### 3.0 LIMITING CONDITION FOR OPERATION (LCO) APPLICABILITY

The information in this section of the reference ABWR DCD, including all subsections, is incorporated by reference with the following departure.

STP DEP 16.3-1

**Figure B 3.3.1.1-1 ADS Inhibit Instrumentation Channels**

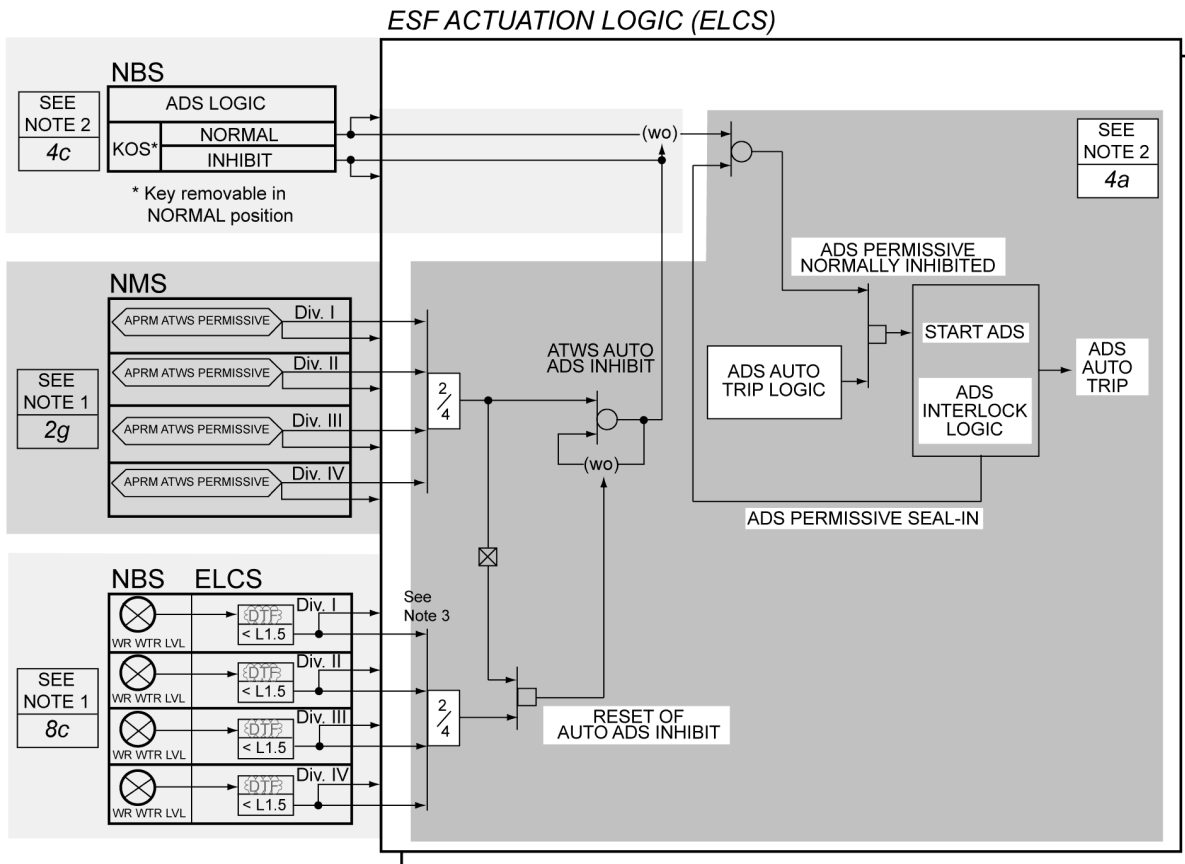
STD DEP T1 3.4-1

Figure B 3.3.1.1-2 RCW/RSW HX Room Leak Detection Instrumentation Channels

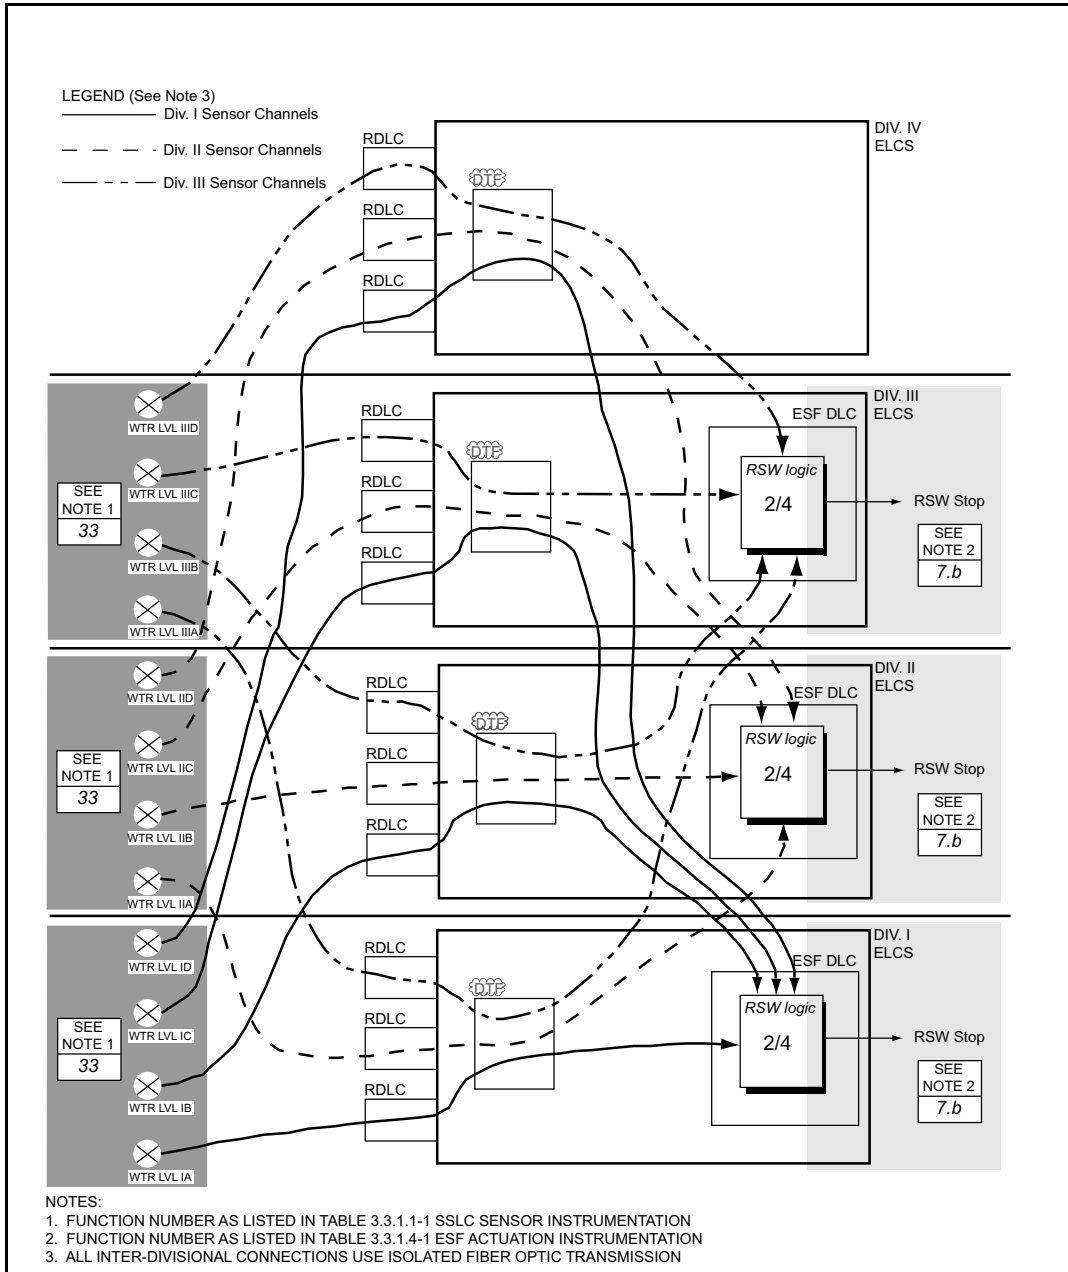
STD DEP T1 3.4-1

**Figure B 3.3.1.4-2 ESF Actuation Channel Structure for LPFL B, C, HPCF B, RCIC**

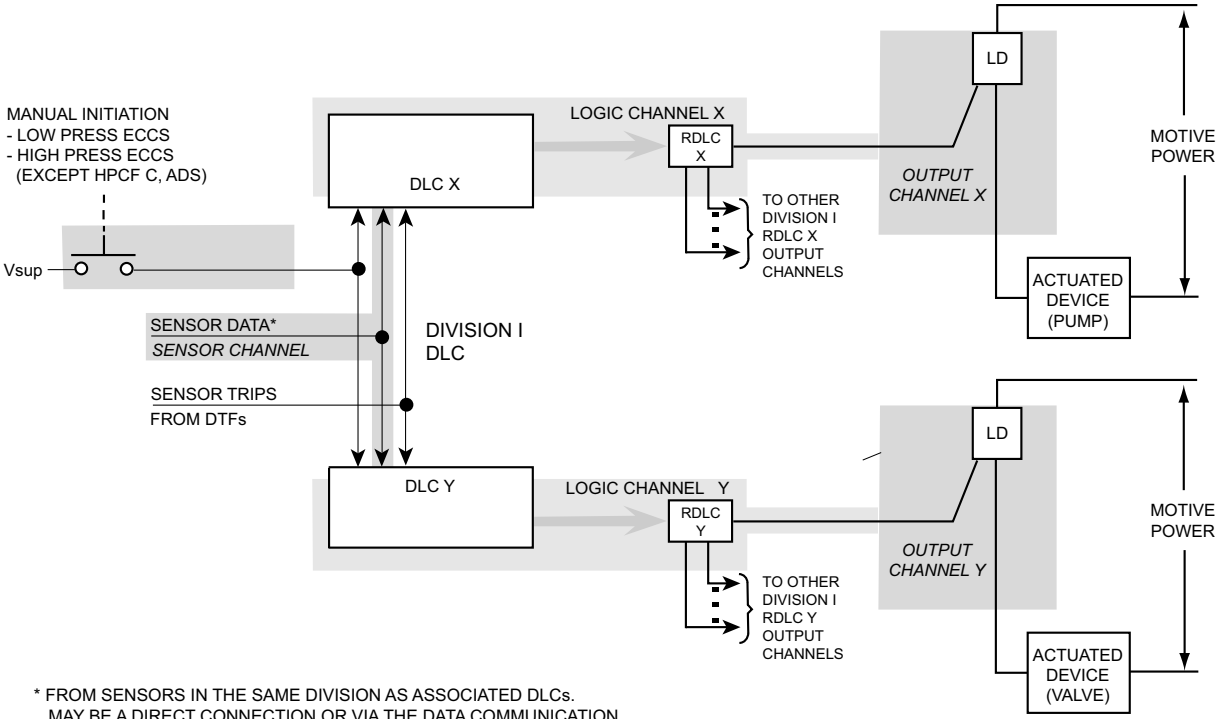
STD DEP T1 3.4-1

Figure B 3.3.1.4-3 ESF Actuation Channel Structure for HPCF C

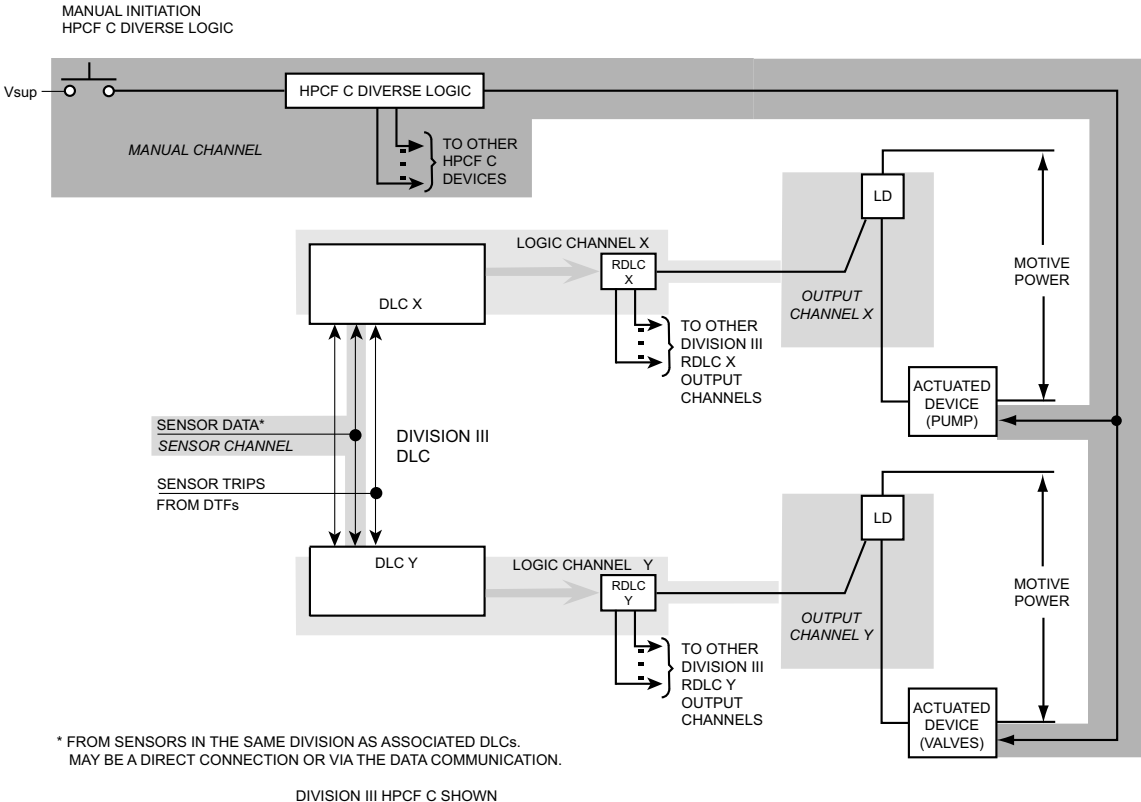
STD DEP T1 3.4-1

Figure B 3.3.4.1-1 ATWS and EOC-RPT Instrumentation Channels

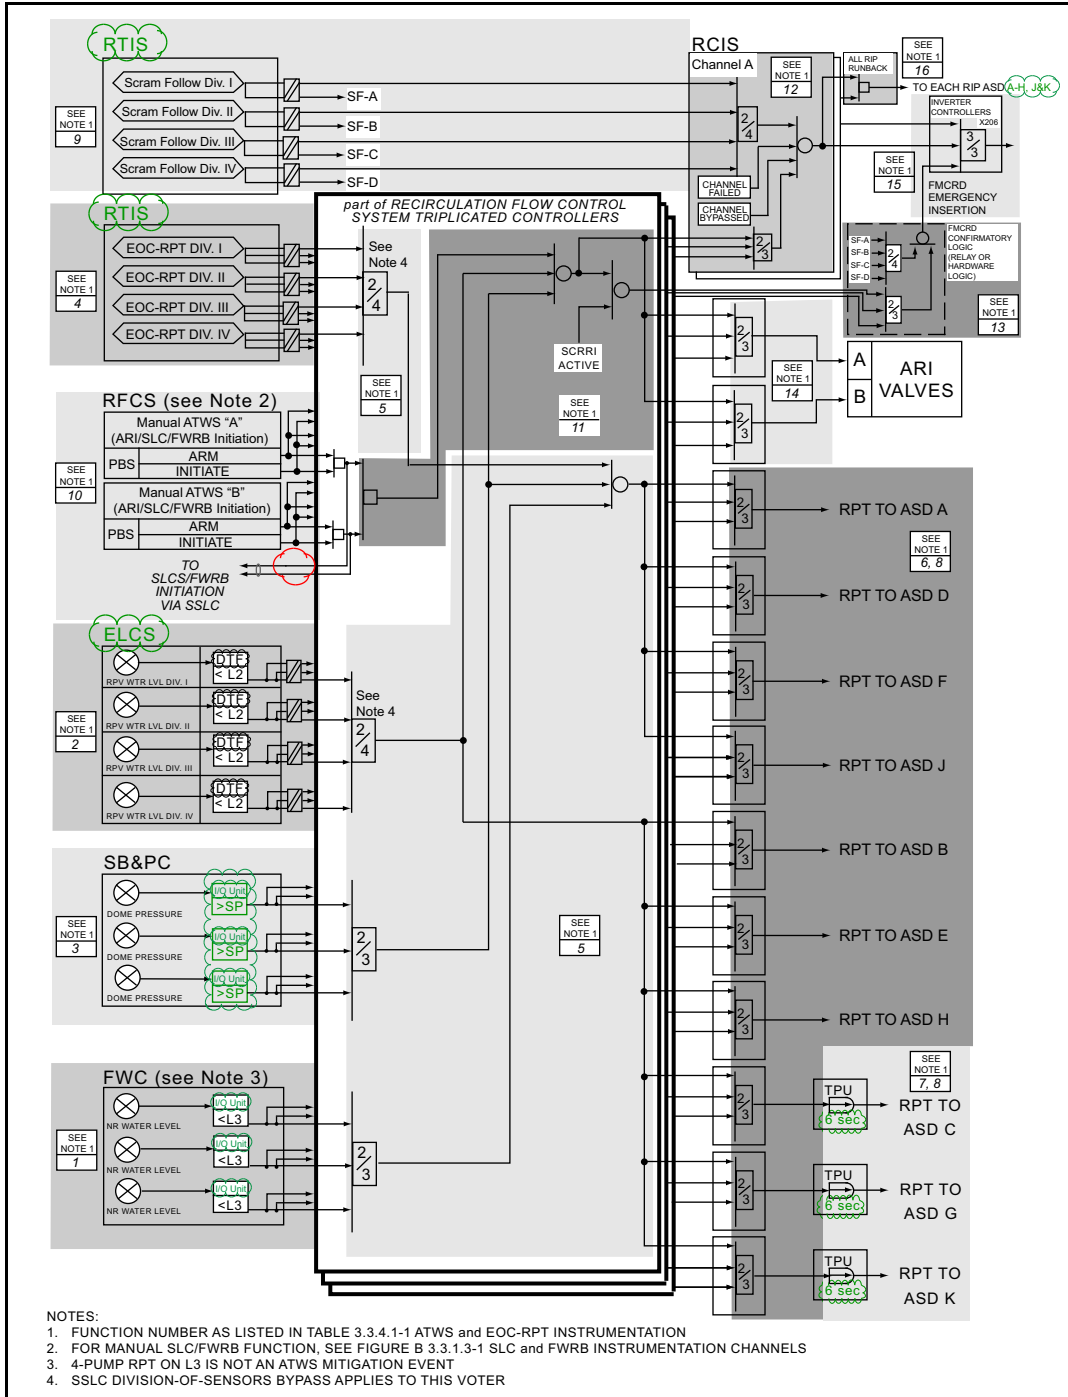
STD DEP T1 3.4-1
